UNITED STATES PATENT AND TRADEMARK OFFICE

APPLICATION NO.	FILING DATE	FIRST NAMED INVENTOR	ATTORNEY DOCKET NO.	CONFIRMATION NO.
10/779,864	02/18/2004	Edwin Eduard Nicolaas Josephus Krijnen	081468-0308328	6215

Office Action Summary

DETAILED ACTION

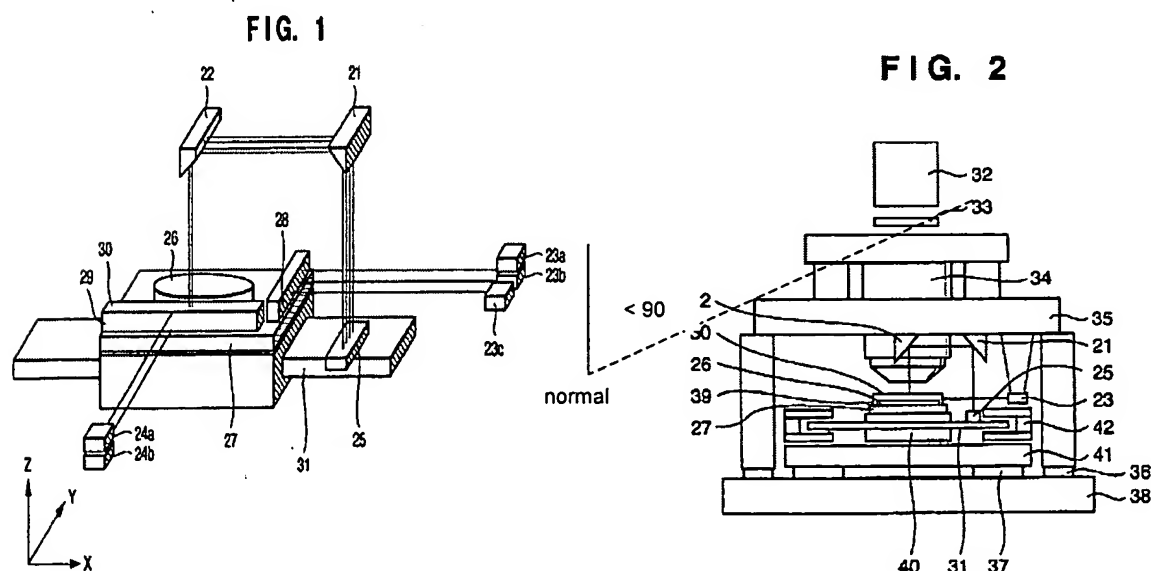
As to claims 1 and 2, Takai et al disclose providing a reference laser beam (column 9, line 57); providing a measuring laser beam (column 9, line 57); reference and measuring laser beams are provided by Z-measuring interferometer 25 in figure 2 shown below; the measuring laser beam is directed substantially perpendicularly incident (column 14, lines 56-59) on a measuring mirror with a fixed position relative to an object (z-measuring mirror 30 is fixed to the top stage 27, which holds the wafer chuck/object as described in column 6, lines 38-43 and column 7, lines 55-59); the normal to the z-measuring mirror 21 may also make a non-zero acute angle with the z-direction (see lines extending from the mirror, as drawn by the examiner and the explanation in column 7, lines 22-27); partly overlapping the reference and measuring beams creates an interference signal by definition; determining a change in the interference signal (column 7, lines 45-54); processing the change to determine displacement of the object along the z-direction (column 7, line 60 thru column 8, line 2).

measuring mirror and a separate mirror fixed with respect to the apparatus. See figure 2, mirrors 21, 22 and 30 (mirror 30 being fixed to top stage 27, on which the wafer chuck resides).

As to claims 18 and 19, Takai et al disclose, in figure 3, additional measuring mirrors, 21, 22, with acute angles with respect to the z-direction (see also the normal drawn in figure 2 above). The two mirrors 21, 22 are on opposite sides of the holder as shown in figure 3.
